Application for Licence Amendment

Licence Number	L8912/2015/1
Licence Holder	Halls Creek Mining Pty Ltd
ACN	168 093 347
File Number:	DER2015/001934
Premises	Lamboo Gold Project M80/343, M80/355, M80/359, M80/362, M80/503, M80/471, L80/70 and L80/71 MUELLER RANGES WA 6770
Date of Report	27/11/2019
Decision	Intent to grant amended licence

Figure 1: Location of proposed and existing infrastructure

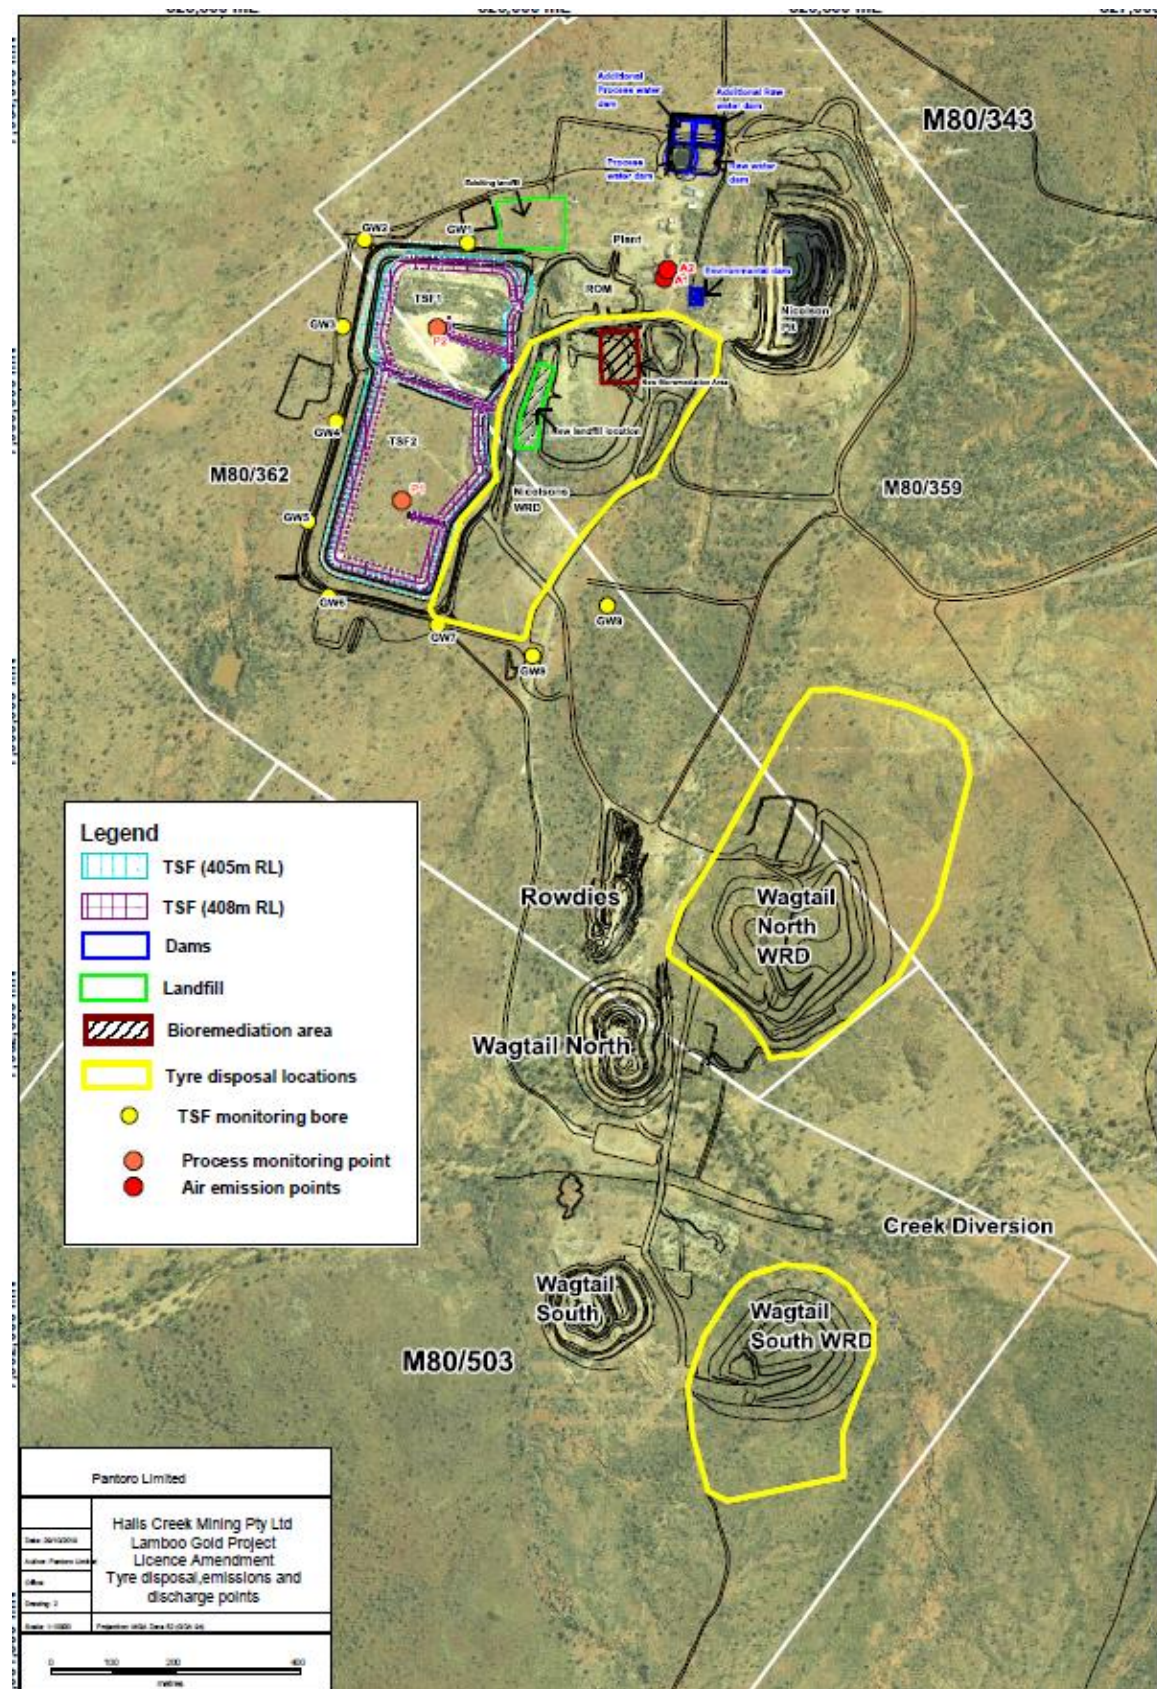
HCM intends to construct and operate a Category 64 landfill within a defined area of the Nicolson's WRD, as shown in Figure 1. Once approval has been received, the existing landfill site (Figure 1) will be closed, and operations will remain the same in that:

HCM currently has approval for burial of tyres within Nicolson's WRD. HCM proposes to also bury tyres within Wagtail North WRD and Wagtail South WRD (shown in Figure 1). Tyres will be disposed of in accordance with the requirements of the *Environmental Protection Regulations 1987* r.14(2) and the existing Licence.

HCM proposes to construct and operate additional raw water and process water 'dams' adjacent to the current dams (as shown in Figures 1 above and Figure 2 below).

Risk of operation of landfilling remains the same, and existing licence conditions remain appropriate for operations at the new landfilling locations. Proposed landfill locations will be updated on the Licence maps.

Figure 2: Proposed ponds

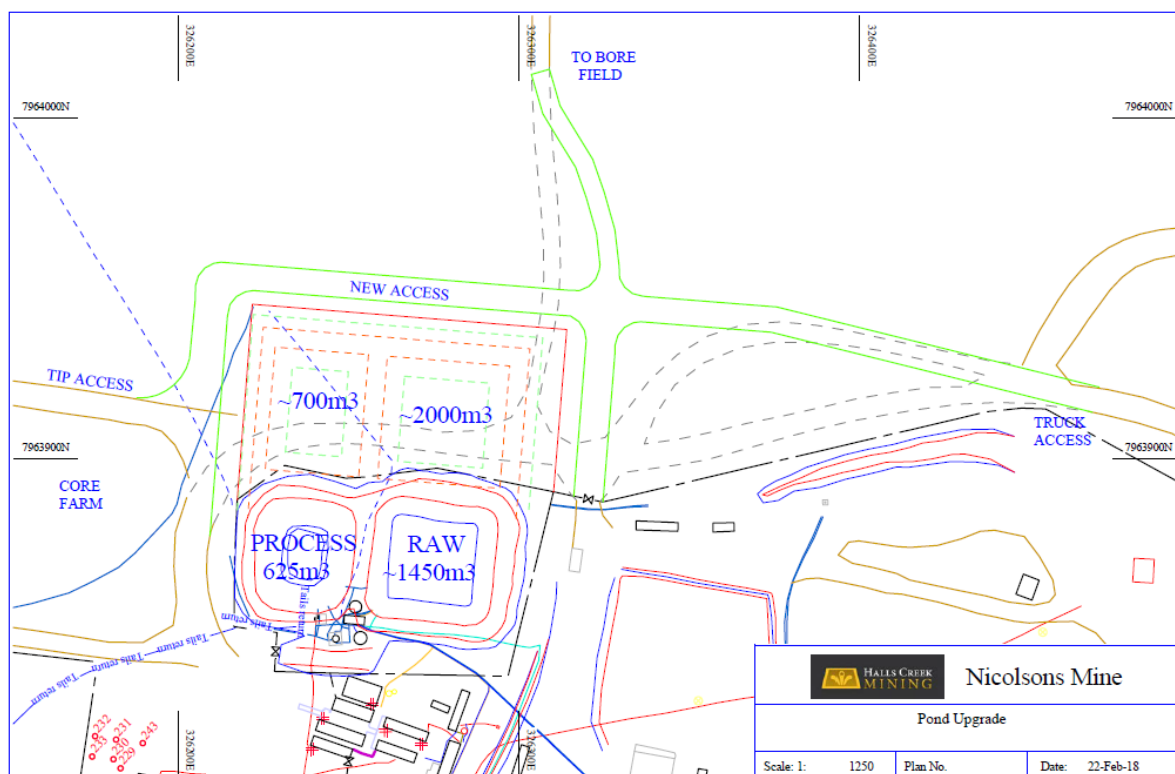
The dams will be lined with HDPE and a freeboard of 300mm maintained as per the existing dams and in accordance with the existing licence conditions.
